DESCRIPTIVE REPORT

General Locality Columbia River

Sublocality Walker Island to Sandy Island

Descriptive Report to Accompany Hydrographic Survey H11856

Figure 2. Artifacts in Reson 7125 bottom tracking algorithm

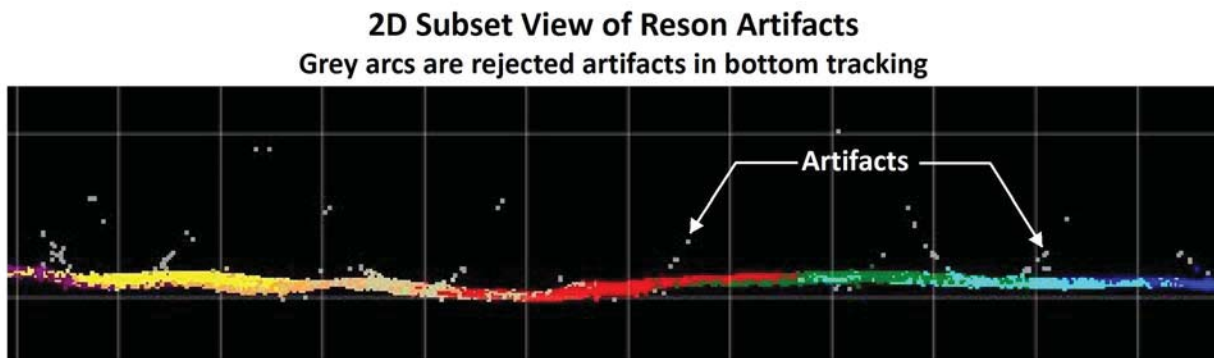
There is an error in the Reson 7125 bottom tracking algorithm that causes bottom detection (beams 86-115 and 140-168) to lock on to stronger sonar returns, bleeding over from more nadir returns. This may be related to the amplitude bottom detection used near nadir and the bottom detection locking on to the strong nadir return signal, rather than the actual bottom return for that designated beam area. These artifacts occur in two areas near nadir and are more prevalent on a hard bottom, when the amplitude of the nadir return is the strongest. The artifacts run along-track and can exceed 20 centimeters in the raw soundings, but are reduced to 5 to 10 centimeters in the CUBE surface.⁹ Attempts to remove these artifacts during survey operations with changes in sonar settings were unsuccessful. Reson is aware of this issue and is working towards a resolution with a different bottom tracking algorithm.

- ⁸ Concur. Compiler recommends a note be added to the charts stating that mariners use caution when navigating outside the maintained channels.
- ⁹ Despite the artifacts from the bottom tracking algorithm, the data meets specification.

Figure 3. Surveyed 27-ft shoal on charted 34-ft sounding

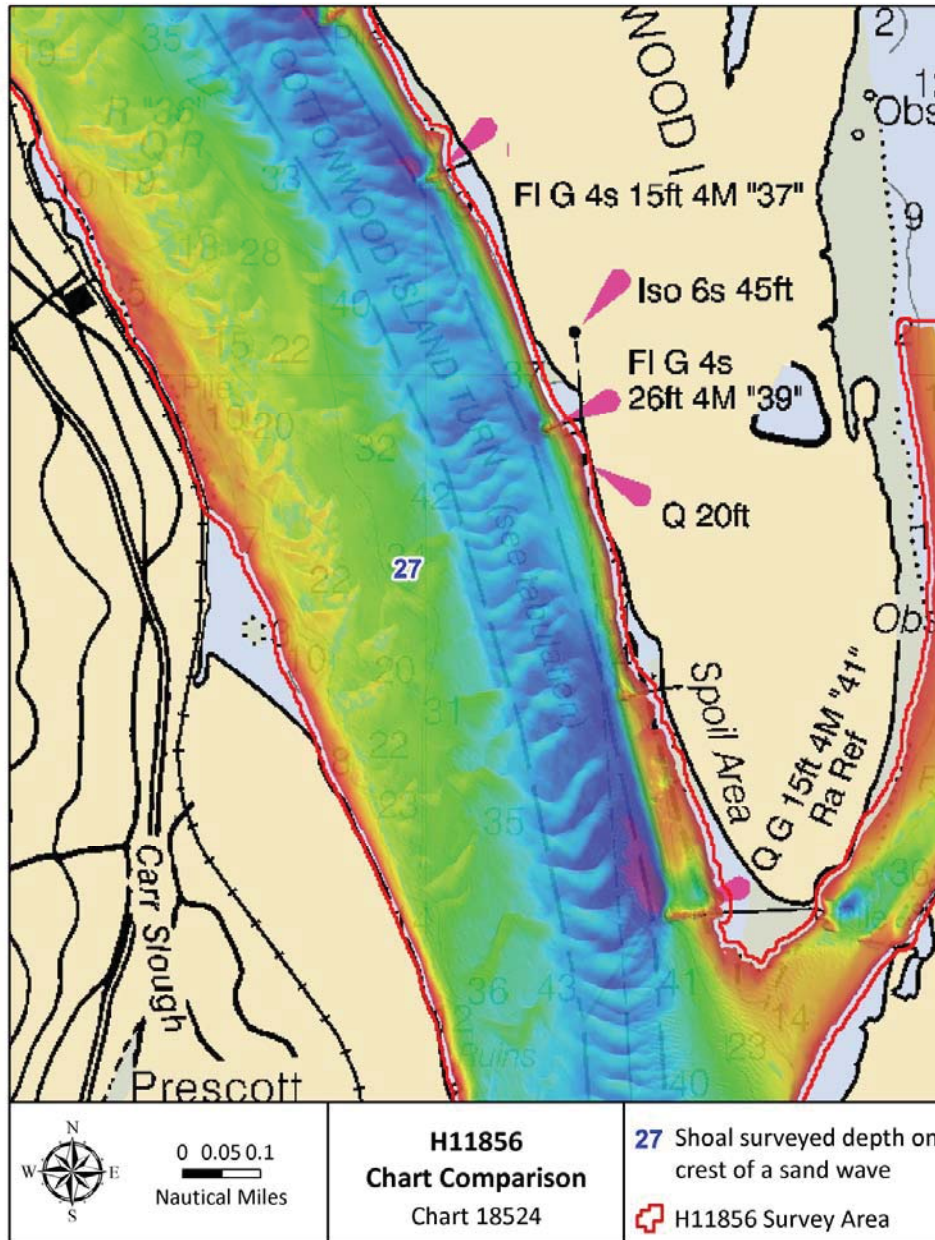
Survey H11856 depths were compared to the charted soundings on Charts 18524 and the corresponding ENC US5OR13M. In general there is good agreement between depths from survey H11856 and the chart. Based on the distribution of the differences, the hydrographer believes that the changes are the result of natural shoaling (Figure 3).¹⁶

- ¹⁰ Concur.
- ¹¹ Filed with hydrographic records.
- ¹² Concur.
- ¹³ Concur.
- ¹⁴ Concur.
- ¹⁵ Filed with project records.
- ¹⁶ Concur. Updated soundings are included in HCell H11856

Figure 4. Migration of shoal in Carrolls Channel

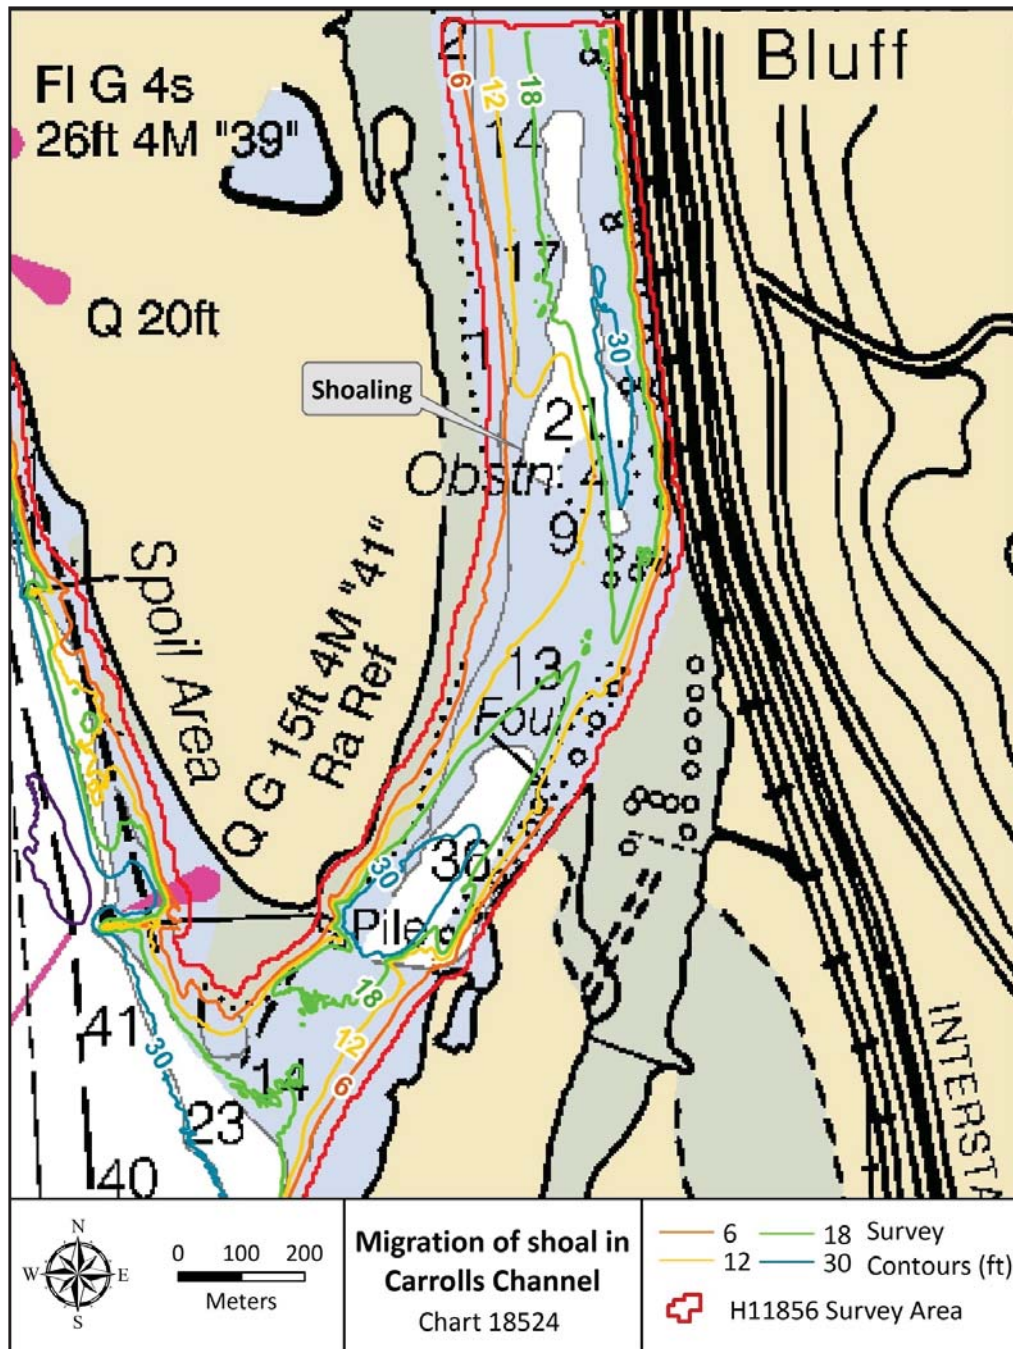
The charted shoal in Carrolls Channel appears to have migrated north eastward (Figure 4, see 12 foot contour line).¹⁷ Also, a new four-foot obstruction was reported as Danger to Navigation (Dton) #3 in this area.¹⁸ The Hydrographer recommends charting the area based on current hydrography.¹⁹

- ¹⁹ Concur.
- ²⁰ Concur. Recommend removing 'Shoaling rep 2004' notation and charting updated soundings included in HCell H11856.
- ²¹ The obstruction is included in HCell H11856.

Figure 5. Chart comparison of charted shoaling

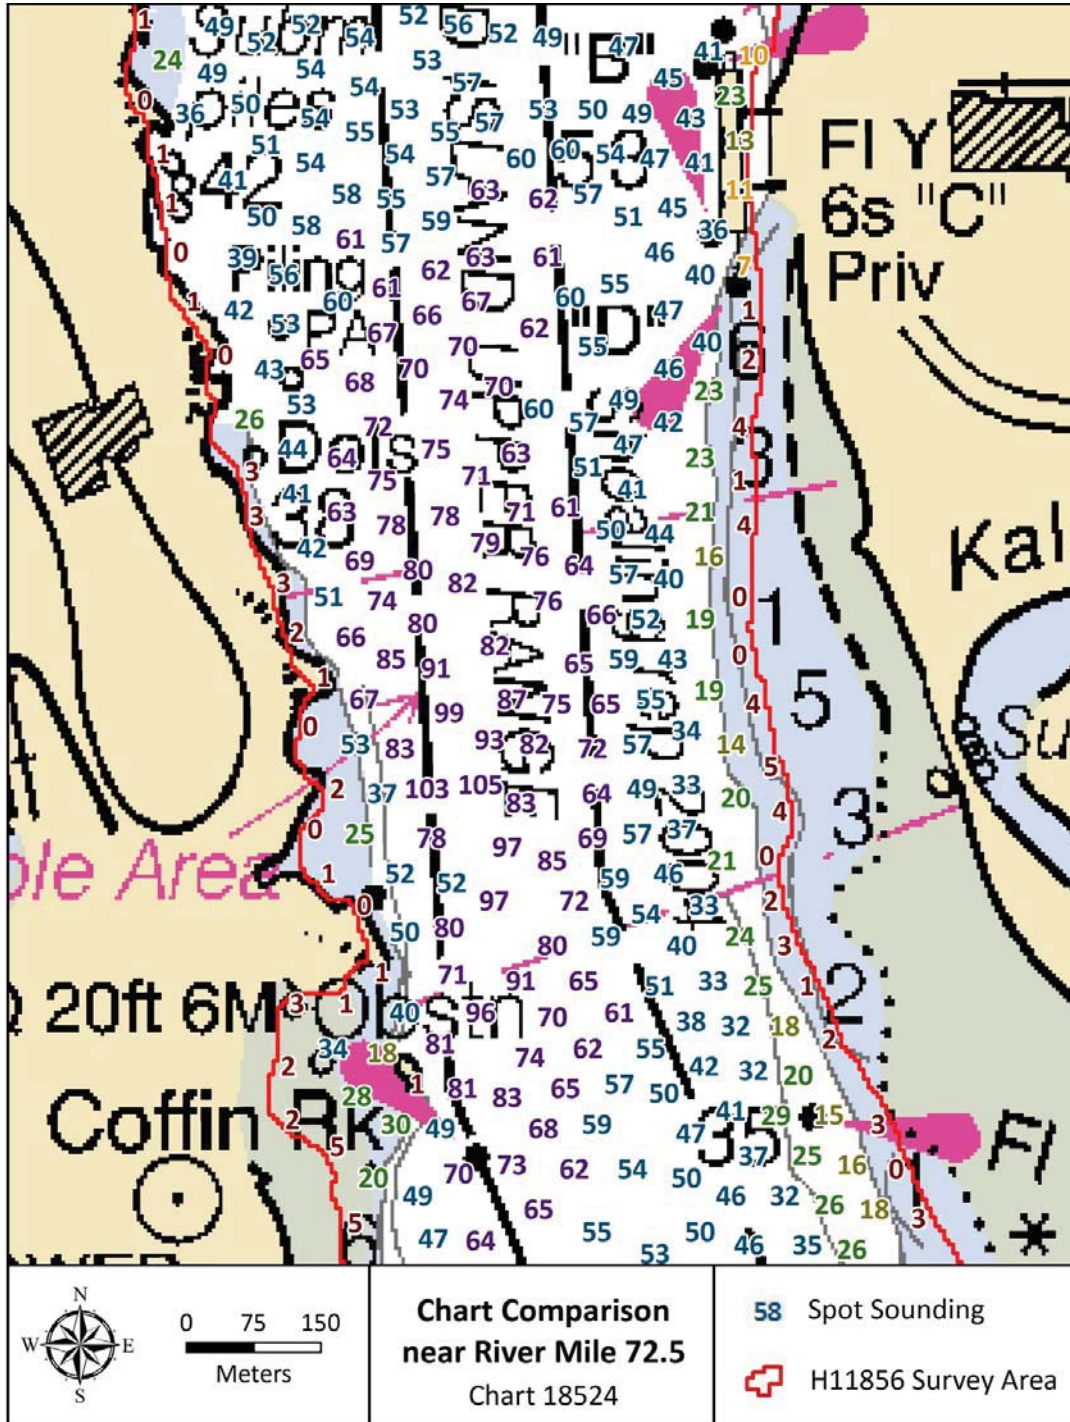
The charted notation “Shoaling rep 2004” (between CRM 72 and 73) was not observed in MBES data Figure 5). The current survey’s 18 foot contour agrees with the charted 18 foot contour in this area.²⁰

Figure 6. H11856 AWOIS investigations

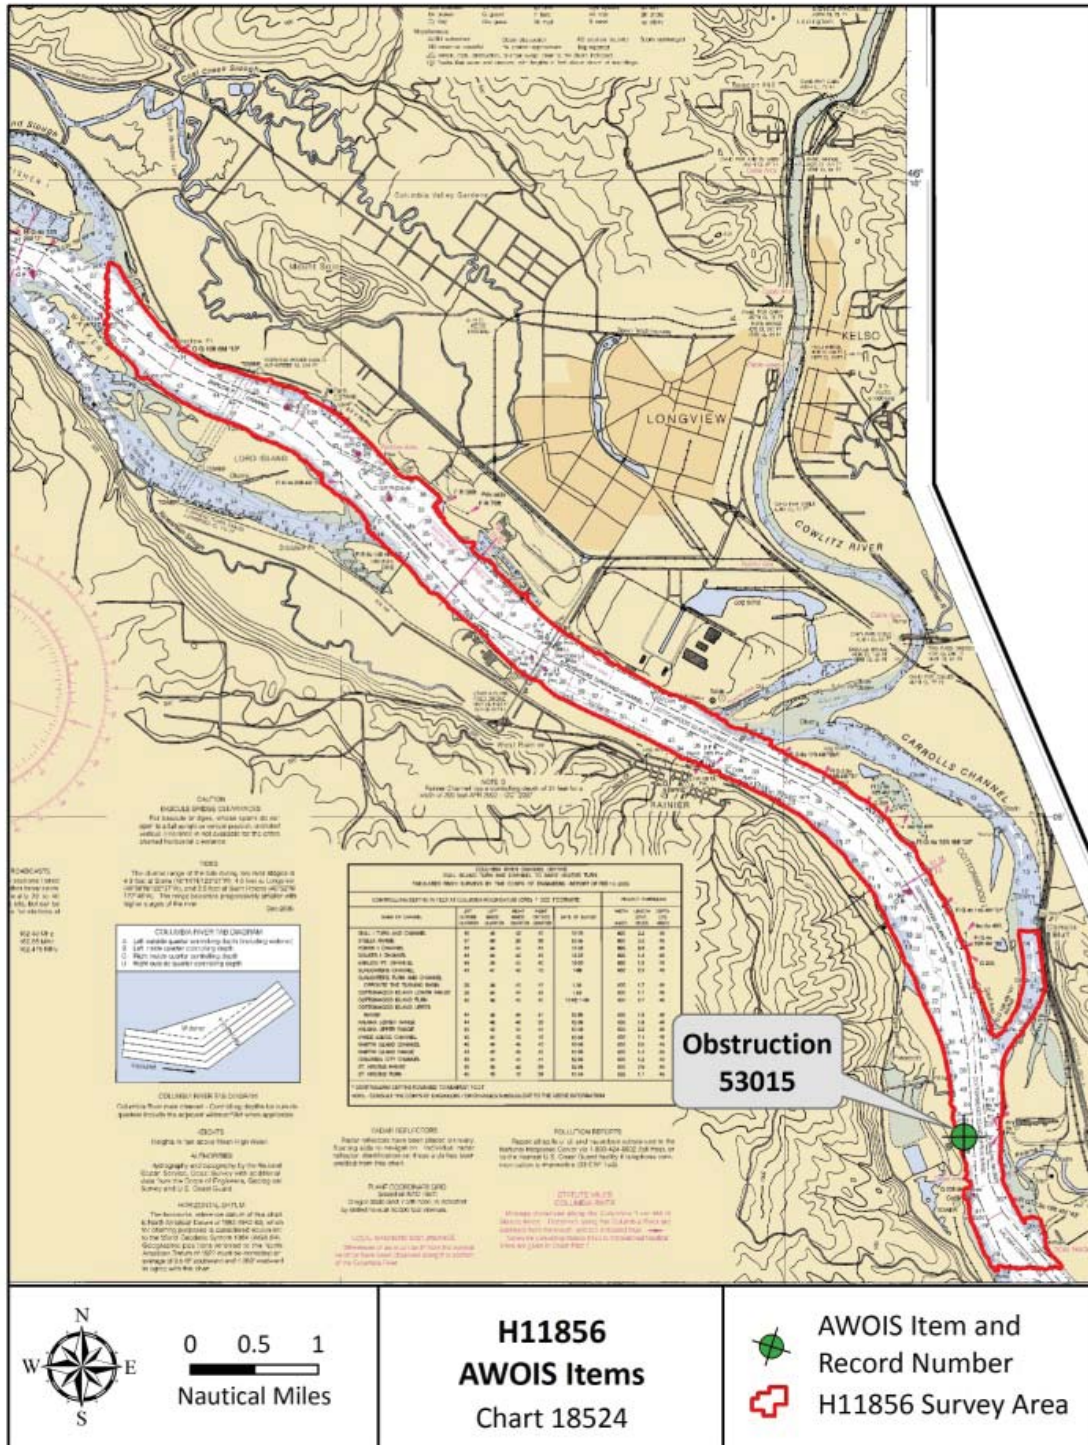
The Piling PA (AWOIS 53015) charted at 46/02/30N, 122/52/54W was investigated with 100% multibeam coverage within the project limits. No large group of pilings was observed; however, there are small features in the Multibeam Echo Sounder (MBES) data that could possibly be pile ruins. A least depth of 39.3 feet (11.99 m) was found on an obstruction within the AWOIS radius.²¹ The hydrographer recommends removing the Piling PA notation from applicable charts and updating the AWOIS database.²² A complete description is available in Appendix 2 *Feature Reports*.

- ²² Concur. Piling PA notation has been blue noted to be removed.
- ²³ Concur.
- ²⁴ Concur.
- ²⁵ The US Army Corps of Engineers Portland District has been contacted and have been made aware of the survey results. Given the fact that the Columbia River Channels are continually being dredged, it is recommended that the tabulated depths for each channel be updated with the latest survey information.

Figure 7. H11856 New submerged features

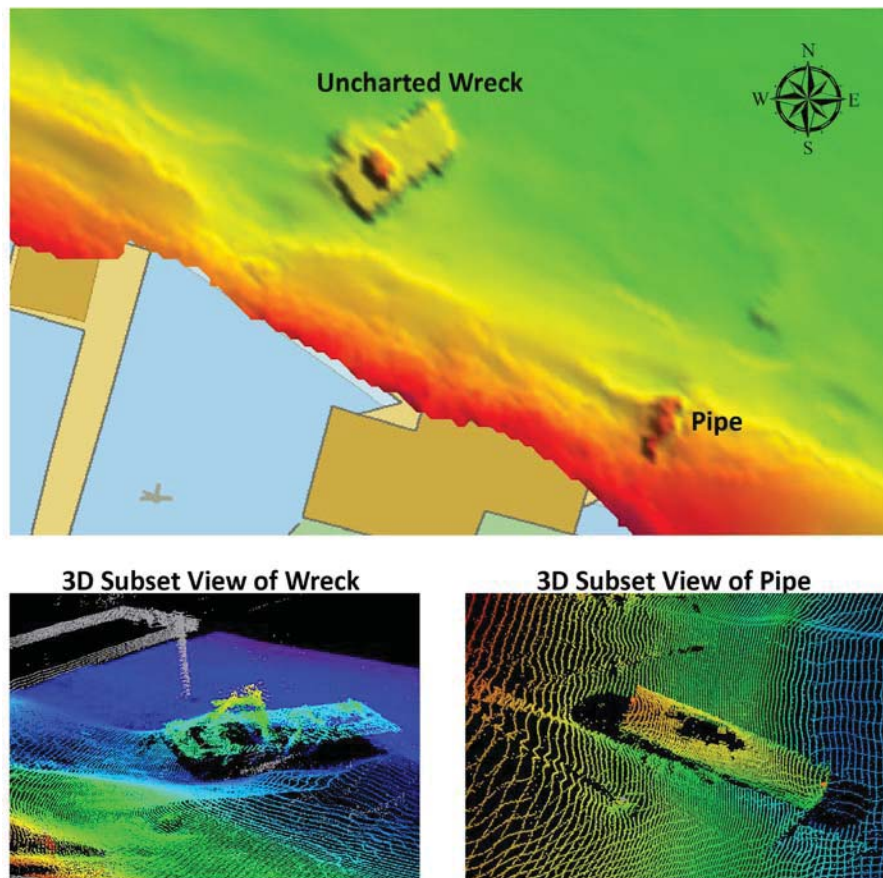
An uncharted wreck was found 60 meters offshore of a charted wreck.²⁹ The charted wreck is attributed as showing mast/masts and always dry. No wreck was observed visually at the charted location. Multibeam coverage over the new submerged wreck is shown next to a pier in Figure 7. In the same area, multibeam data found what appears to be a pipe section 30 feet long and 6 feet in diameter, just off of the Rainier, OR pier facility. Additional information on all new features can be found in Appendix II *Survey Feature Report*.

- ²⁸ See attached feature report.
- ²⁹ The new submerged wreck is included in the HCell. It is recommended that the new wreck located at 46-05-25.0152N, 122-55-51.5136W be added to the AWOIS database.

Figure 8. H11856 New elevated pipeline

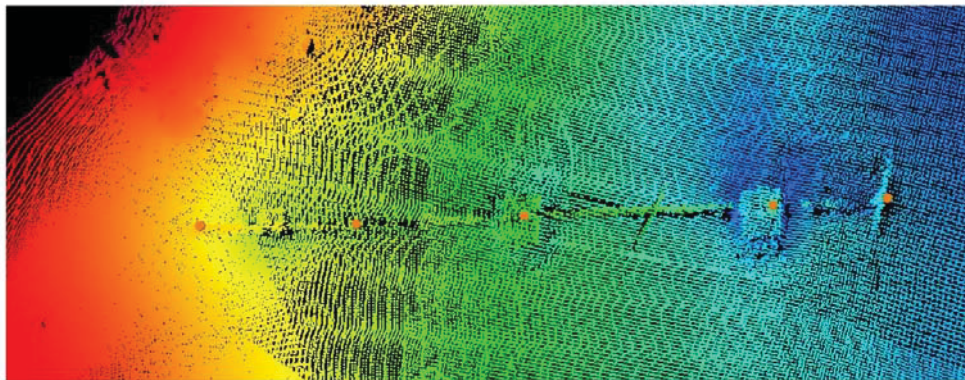
There are two charted pipeline areas located along the north bank of the Columbia River. One pipeline area is located between CRM 63-64 and the other is located between CRM 67-68. A pipeline is visible in the multibeam data at CRM 63-64 and is charted correctly. Three (3) additional pipelines were located during survey H11856. Two (2) of the pipelines are buried but visible in multibeam data. The third, which is located CRM 72 and 73 and approximately 220 meters downstream of a charted cable area, appears to be an elevated pipe secured to blocks on the river bottom (Figure 8). The pipelines are included in the S-57 feature file and additional information can be found in Appendix II *Survey Feature Report*.³⁶

³⁶ The three new pipeline features are included in the HCell as linear blue notes (cartographic lines objects) indicating the locations, lengths and orientations of the pipelines. It is recommended that the new pipeline features be charted.

Figure 9. Sand wave migration

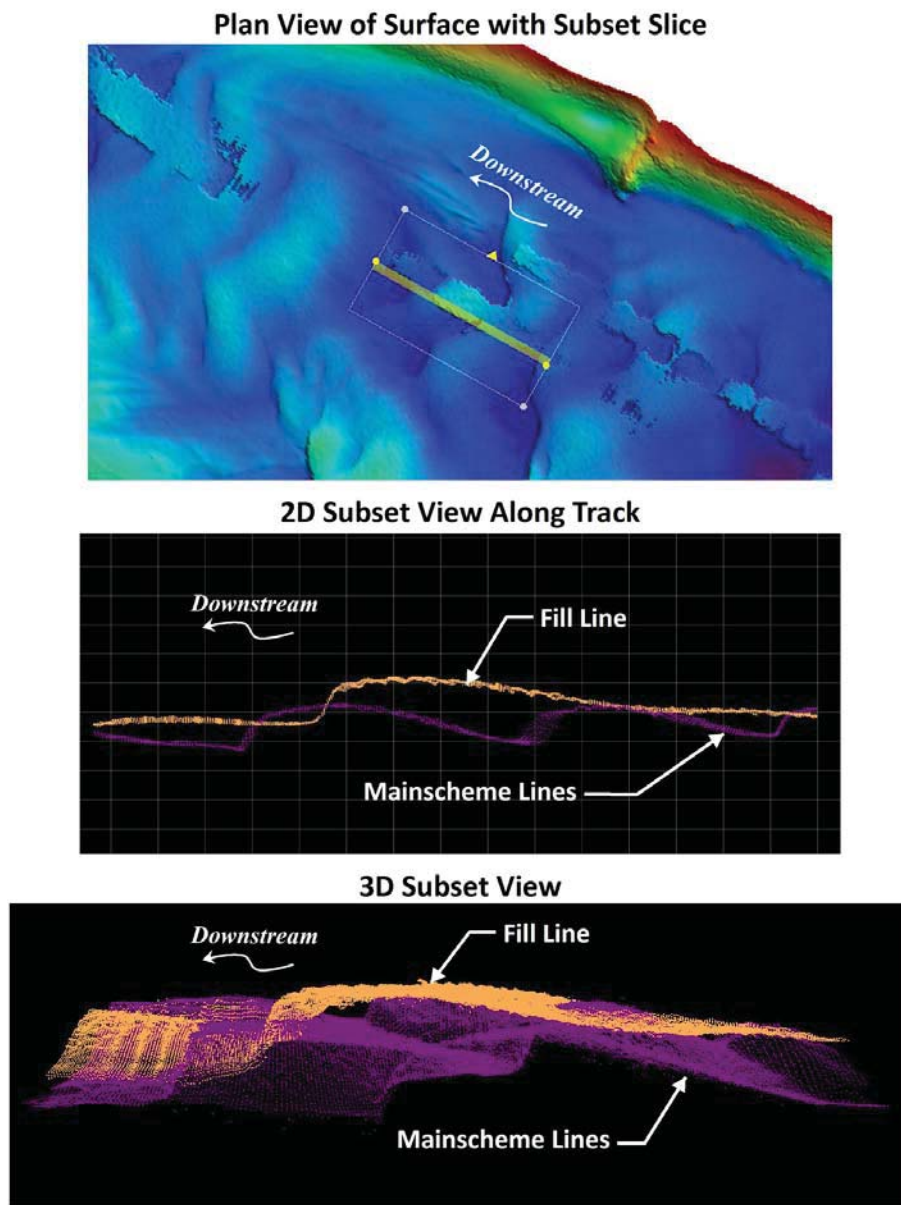
Although the survey exceeds IHO Order 1 accuracy requirements, environmental conditions degraded the quality of the survey data. Due to the dynamic nature of the Columbia River with its heavy sediment transport, sand wave migration (up to one meter of downstream migration per day), has altered the river bottom over time, creating an offset between fill and mainscheme data.³⁷

³⁷ These data are adequate to supersede charted data in the common area despite the shifting nature of the sandwaves. Compiler recommends a note be added to the chart stating that mariners use caution when navigating outside the maintained channels.
